Mesaba Energy Project, PUC Docket No. E6472/GS-06-668

Comments on Draft EIS

Subject: Draft EIS Comments  
Mesaba Energy Project  
DOE/EIS – 0382D

### Potential CO<sub>2</sub> reservoirs: not a constraint most places.

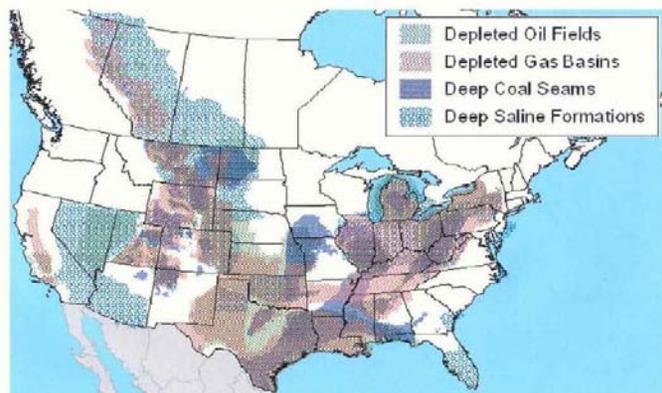
As you can see, Minnesota is about as far away as you can get from a potential CO<sub>2</sub> reservoir. Excelsior states they have been participating in the Plains CO<sub>2</sub> Reduction Partnership, yet PCORP has found a desired distance of less than 125 miles from carbon source to geologic sink for CO<sub>2</sub> sequestration. It is approximately 400 miles from Excelsior's proposed West Site to the nearest reservoir in North Dakota, and much further to actual sites of enhanced oil recovery in Canada.

The DEIS is accurate in that there is no viable way for the Mesaba Project to sequester CO<sub>2</sub>, and there is no economic way to capture the CO<sub>2</sub>. If the DOE really desires an IGCC project as part of its Clean Coal Initiative, CCS needs to be in the design. Without CO<sub>2</sub> capture and sequestration, the Mesaba Project is without merit and should not be allowed to continue forward.

See responses to Comments 1-01, 4-01, 4-03, and 53-04, which address the same concerns.
